Subject: Braidwood Nuclear Power Station
Unit 1 Cycle 9 Core Operating Limits Report

Braidwood Station, Unit 1
Facility Operating License No. NPF-72
NRC Docket No. STN 50-456

Attachment: Core Operating Limits Report, Braidwood Unit 1 Cycle 9, Sequence 2

Subject Braidwood Unit 1 Cycle 9 Core Operating Limits Report

Figure 2.6.2.e

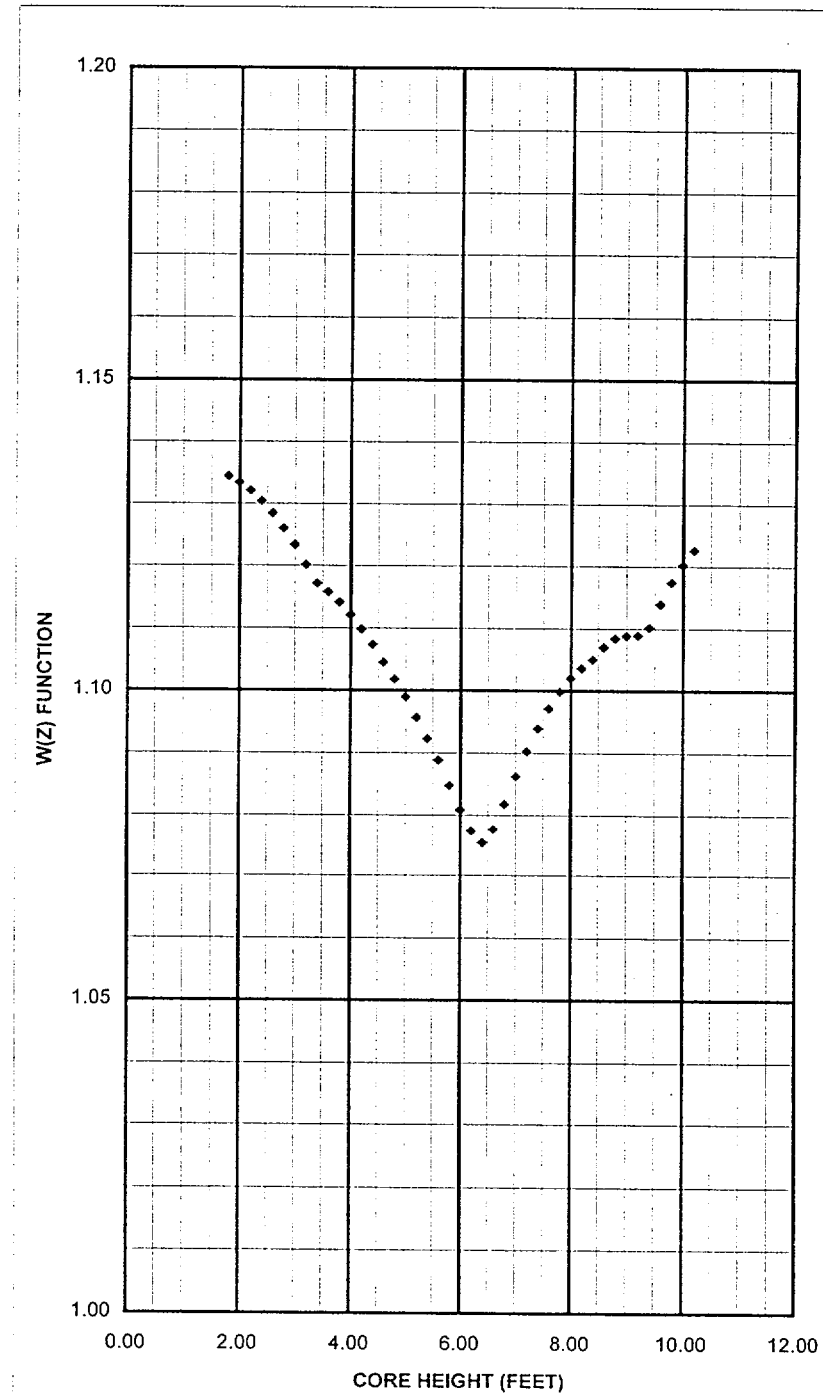
2.6.2 $W(Z)$ is provided in Figures 2.6.2.a through 2.6.2.d for AFD band of +5/-10, and Figures 2.6.2.e through 2.6.2.g for AFD band of +5/-8.

2.8.1 The AXIAL FLUX DIFFERENCE (AFD) target band is typically [+5, -10%]. AFD band can be [+5, -8%] when modified W(z) curves are used (COLR Figures 2.6.2.e, f and g).
(refer to procedure BwCB-1 Figures 19A-D for the current AFD band in use)
